STAFF REPORT SAN CLEMENTE PLANNING COMMISSION

SUBJECT: **General Plan Amendment 19-291, Specific Plan Amendment 19-292, Pier Bowl Specific Plan Update**, a request to: 1) review and discuss amendments to the Centennial General Plan, an update of the Pier Bowl Specific Plan, and the certification of Addendum No. 3 to the General Plan Environmental Impact Report; and 2) continue this item to October 16, 2019.

Figure 1 –Changes to General Plan Designations and Overlays*

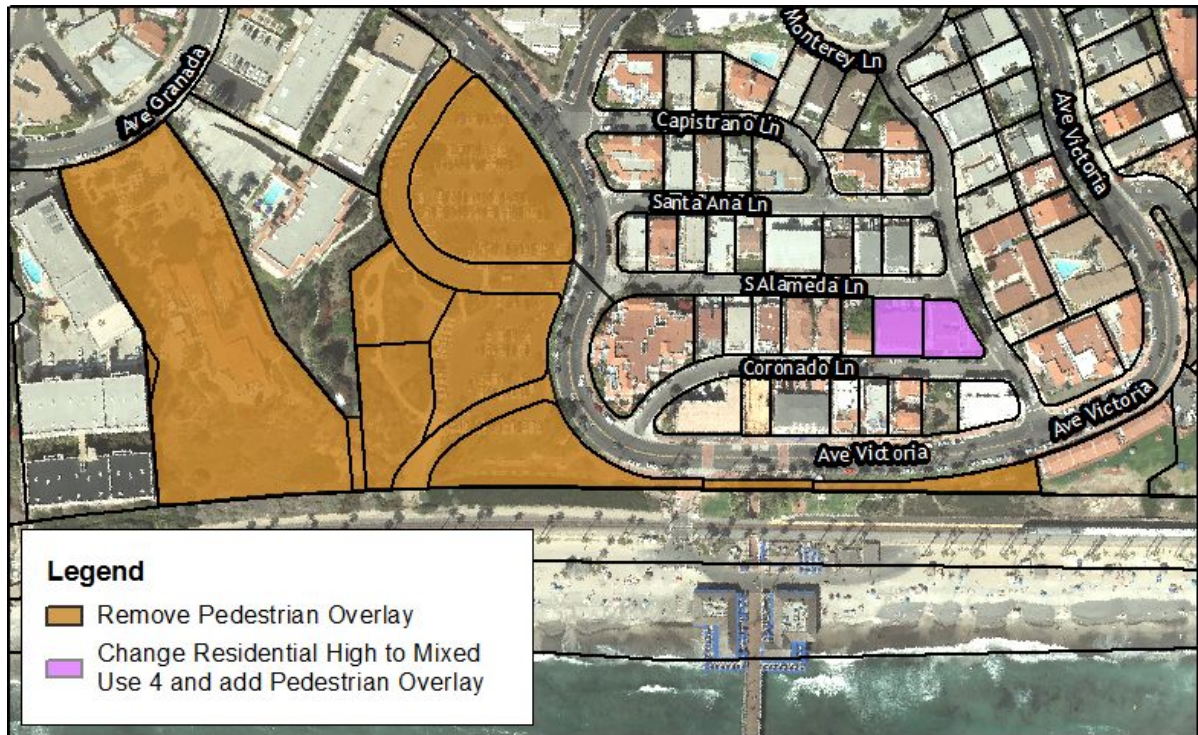
General Plan Amendment 19-291 changes land use and overlay designation changes of properties to achieve consistency between the General Plan and LUP, pursuant to the California Government Code. This amendment modifies maps only; no text changes to the General Plan are proposed. The proposed amendments are provided in the draft Resolution as Exhibit B of Attachment 2, and summarized below.

Figure LU-1A
Land Use

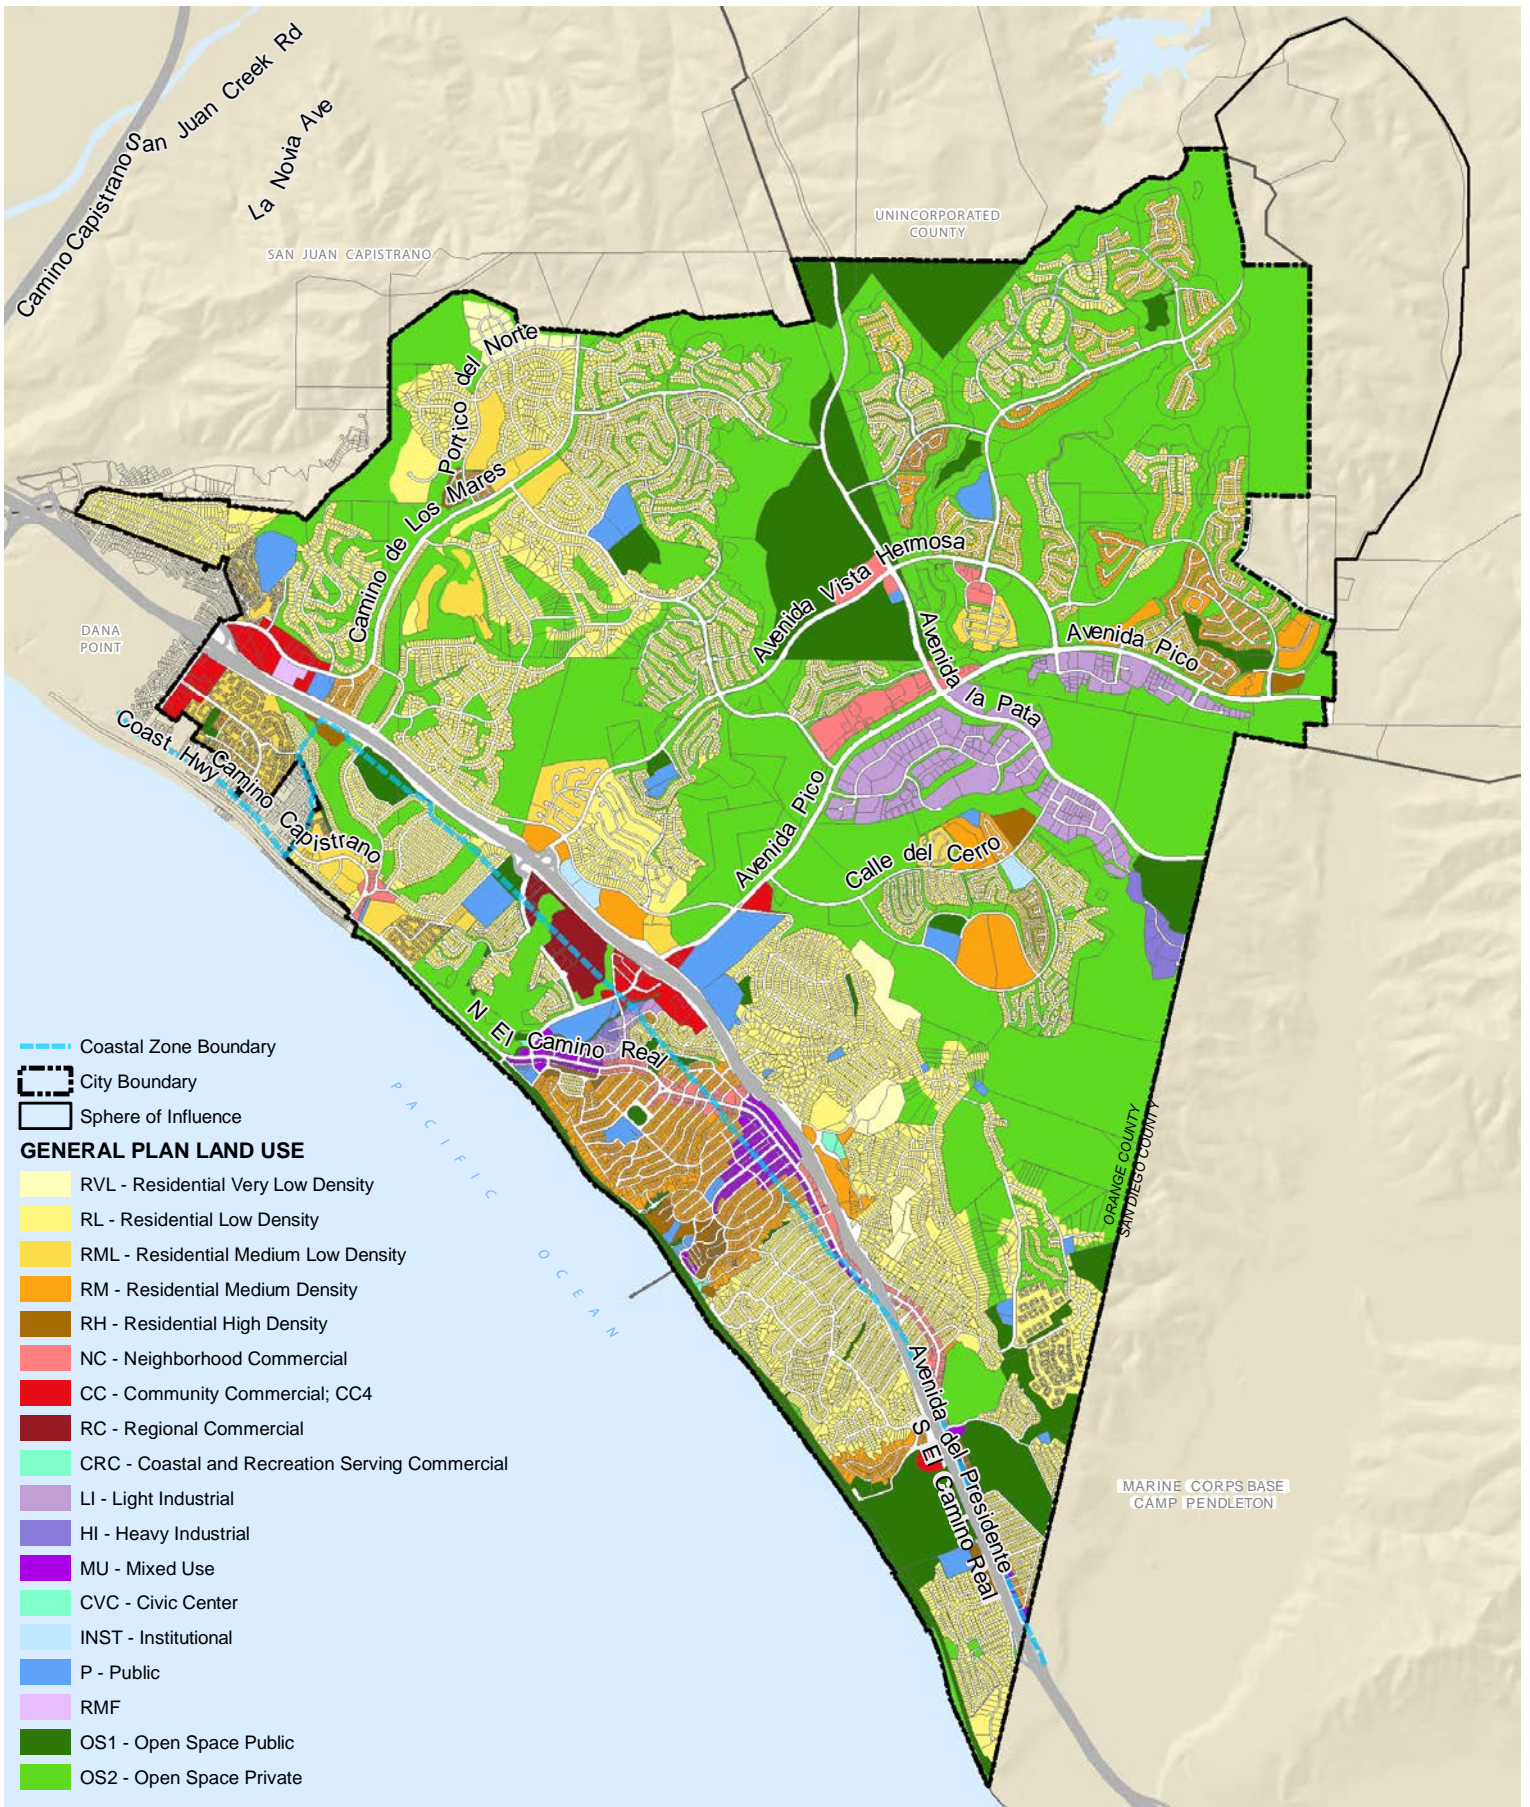
Change No.	Element	Section, Figure, Table	Page No.	Comments
1	Land Use	Figure LU-1A Land Use	LU-40	Changed land use designation of two parcels on southeast end of block of Avenida Coronado Lane from Residential High (RH) to Mixed Use 4 (MU4) to be consistent with the Local Coastal Program Land Use Plan (LUP). <i>(See purple shaded parcels below)</i>
2	Land Use	Figure LU-1B Overlays	LU-41	1) Added Pedestrian Overlay to two parcels on Coronado Lane changed from RH to MU4 (by change no. 1 above) and removed Pedestrian Overlay from Public designated parcels in the Pier Bowl, consistent with the LUP, including the Casa Romantica, municipal parking lots, and Parque Del Mar along Avenida Victoria <i>(See brown shaded parcels below)</i>
3	Land Use	Figure LU-3D Commercial and Mixed Use – Pier Bowl	LU-47	Updated the map to show land use and overlay changes of two parcels on Coronado Lane, described in the rows above

Figure LU-1B
Overlays

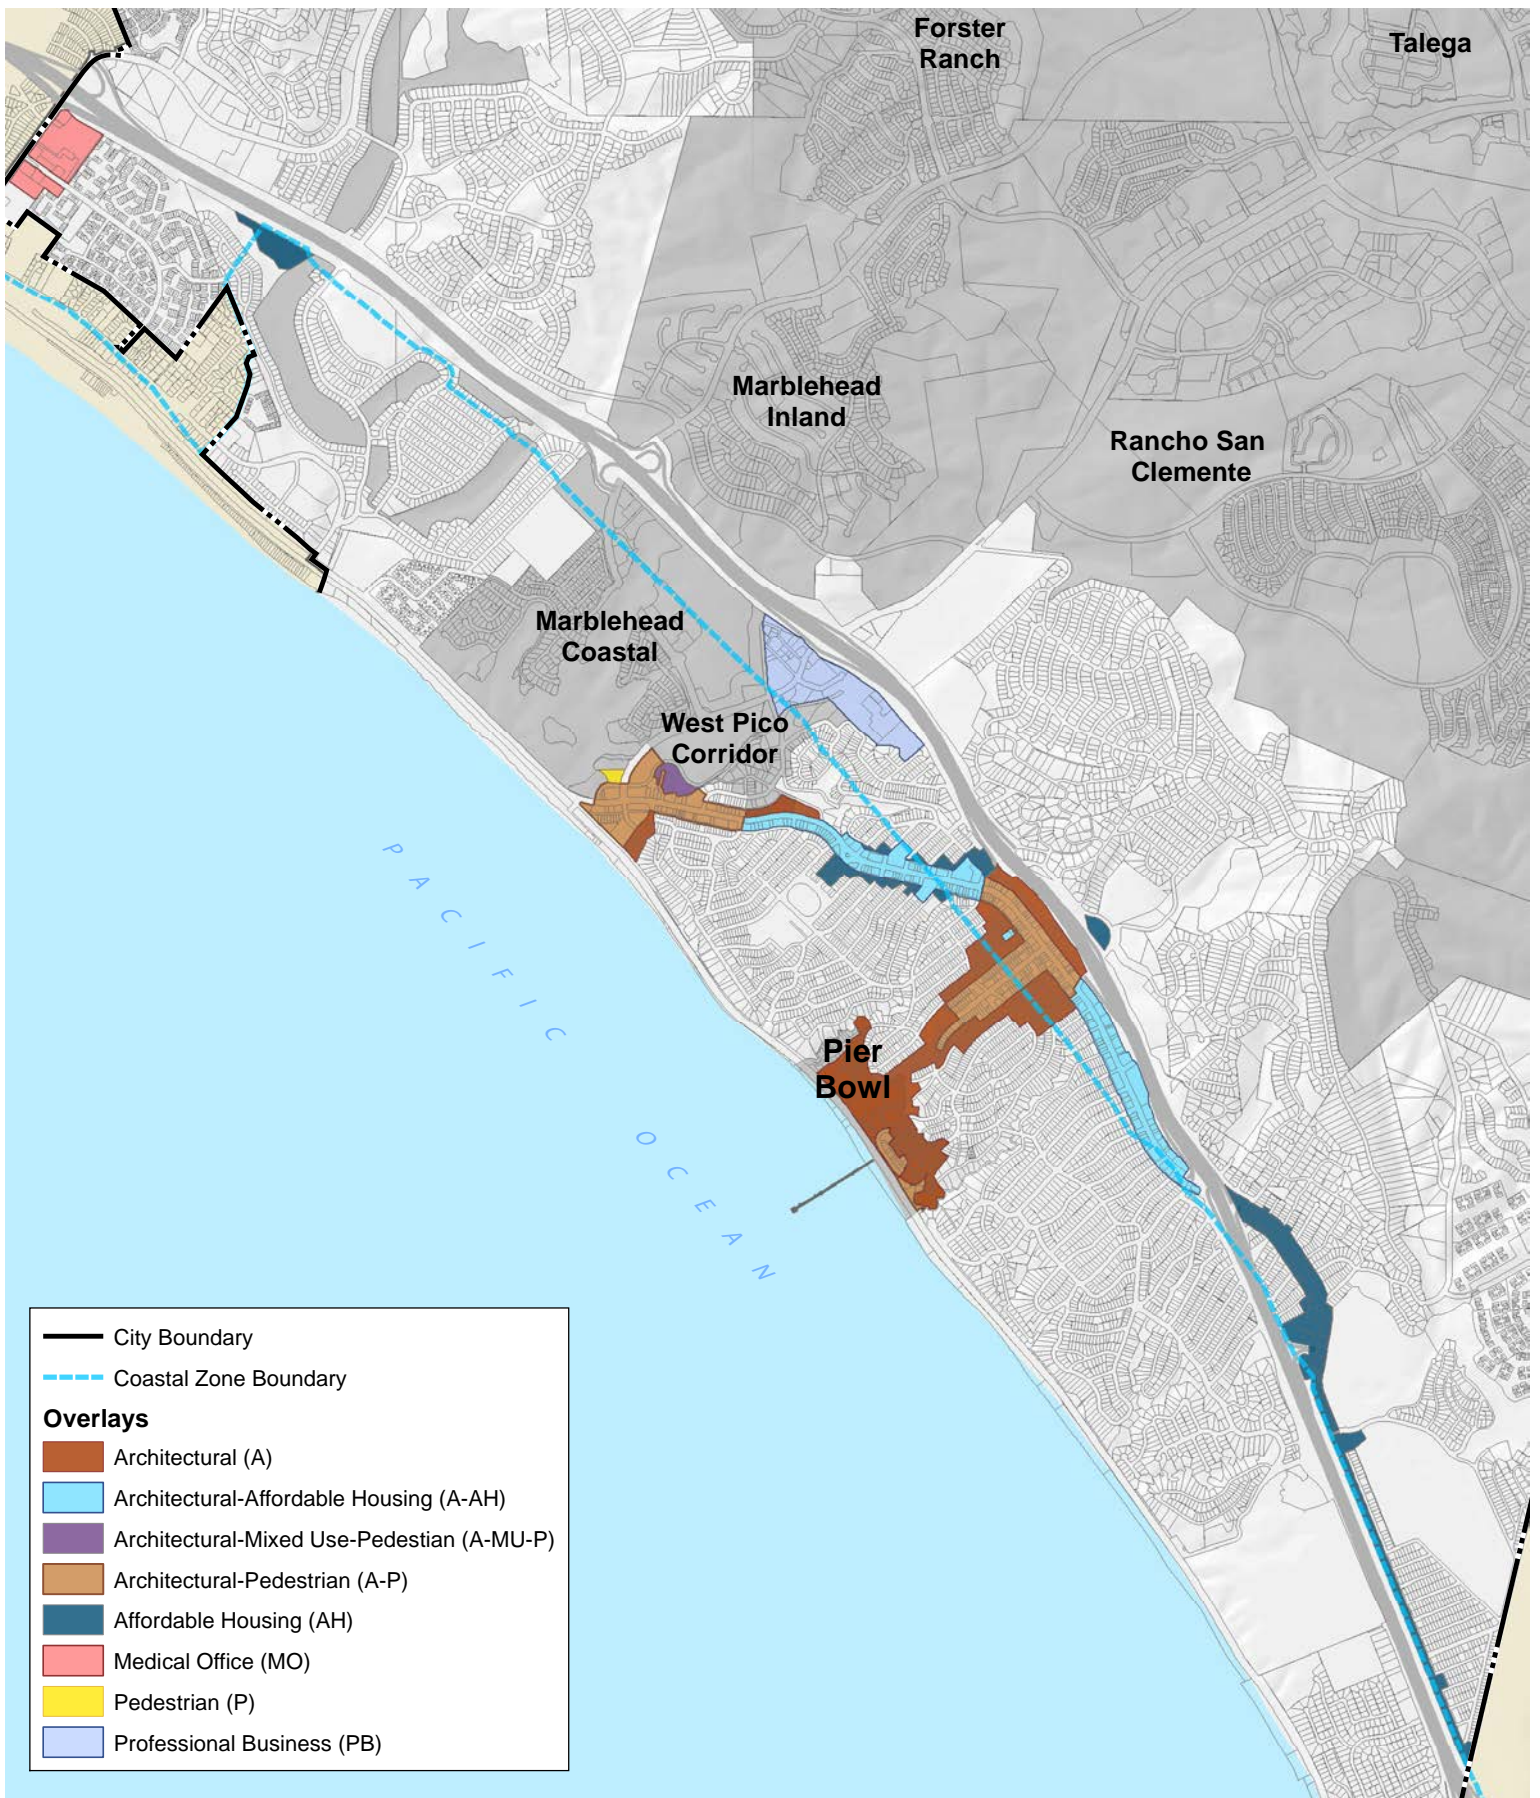
Section 2. Land Use Element Figure “LU-1B, Overlays” is hereby replaced with the figure enclosed in this exhibit.

Figure LU-3D

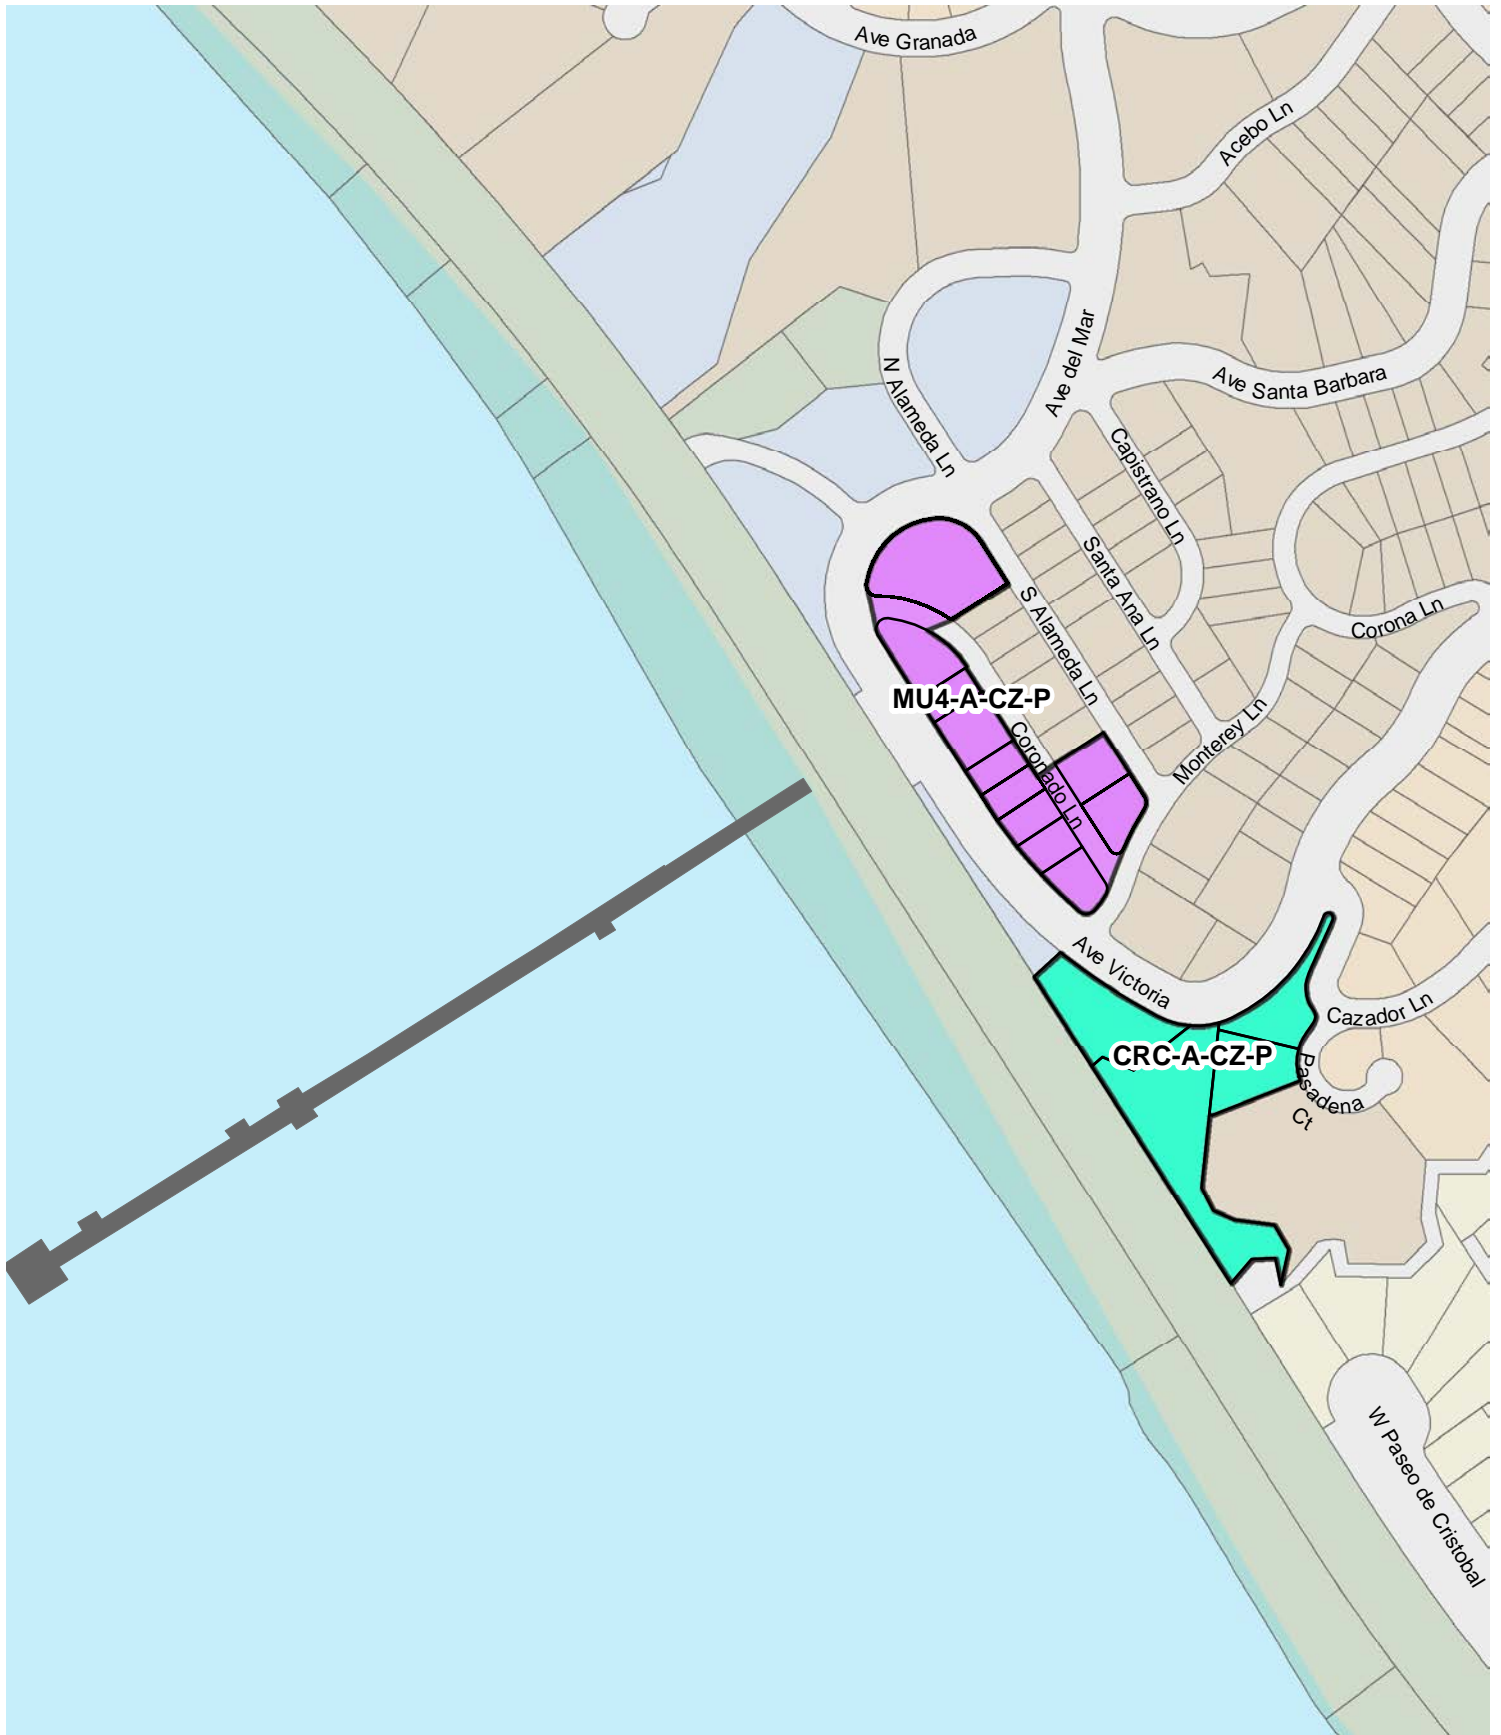
Section 3. Land Use Element Figure “LU-3D, Commercial and Mixed Use – Pier Bowl” is hereby replaced with the figure enclosed in this exhibit.
